# RENESAS TECHNICAL UPDATE

Product Category	MPU/MCU		Document No.	TN-RX*-A201A/E	Rev.	1.00
Title	Errata to RX230 Group, RX231 Group User's Manual: Hardware		Information Category	Technical Notification		
Applicable Product	RX230 Group, RX231 Group	Lot No.	Reference Document	RX230 Group, RX231 Group User's Manual: Hardware Rev.1.10 (R01UH0496EJ0110) Technical Update TN-RX*-A200A/E		
		All

This document describes corrections to the RX230 Group, RX231 Group User's Manual: Hardware, Rev.1.10.

**Figure 50.12**  $V_{OH}/V_{OL}$  and  $I_{OH}/I_{OL}$  Temperature Characteristics at  $V_{CC} = 5.5$  V When Normal Output is Selected (Reference Data)

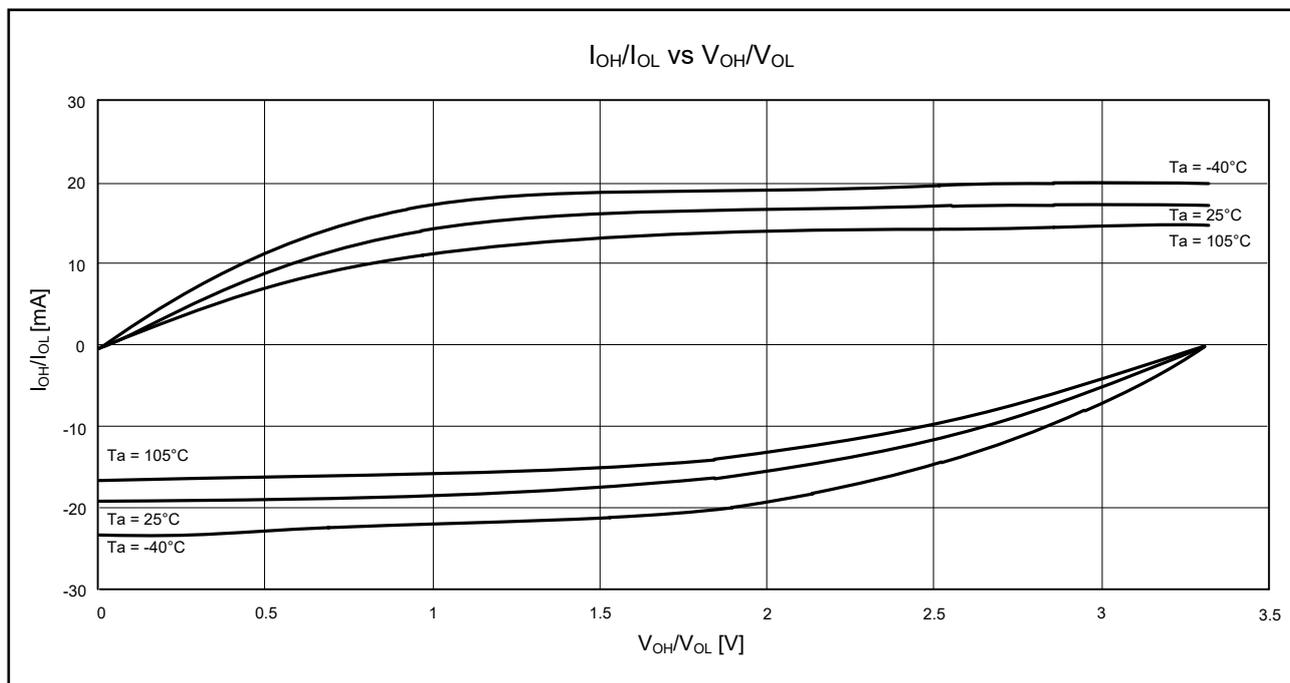
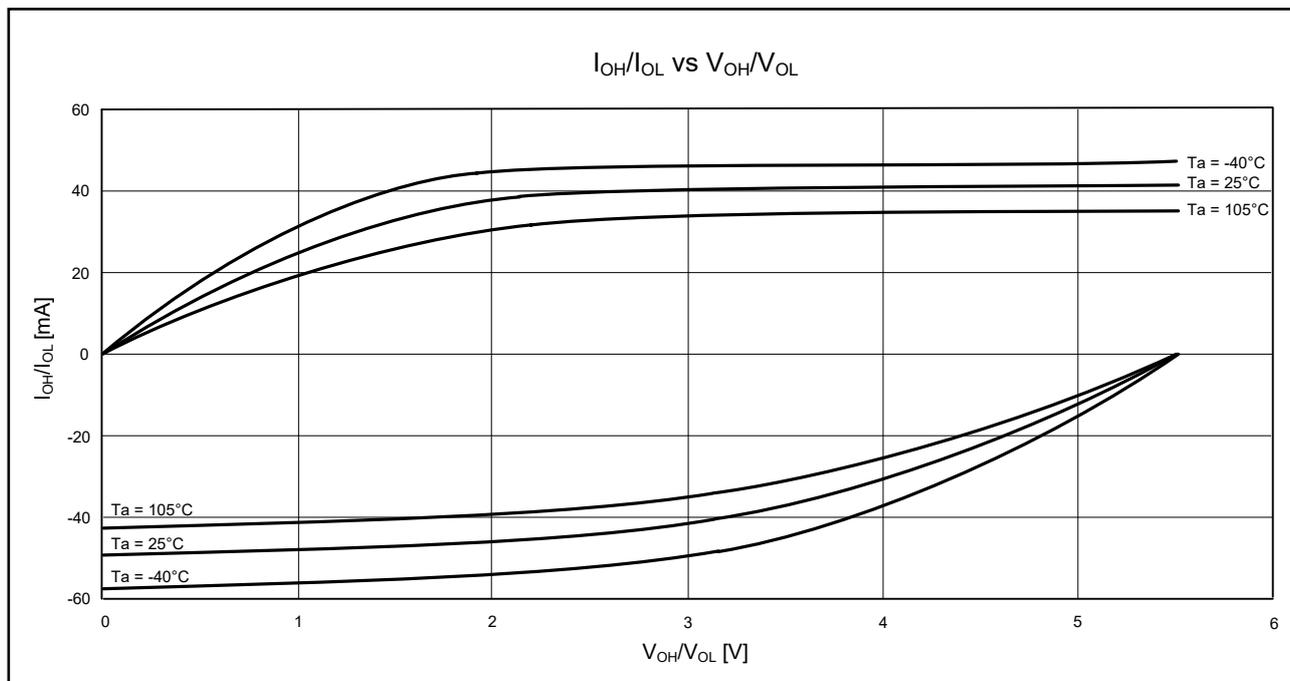
•Page 1897 of 1977

Figure 50.12 is corrected as follows.
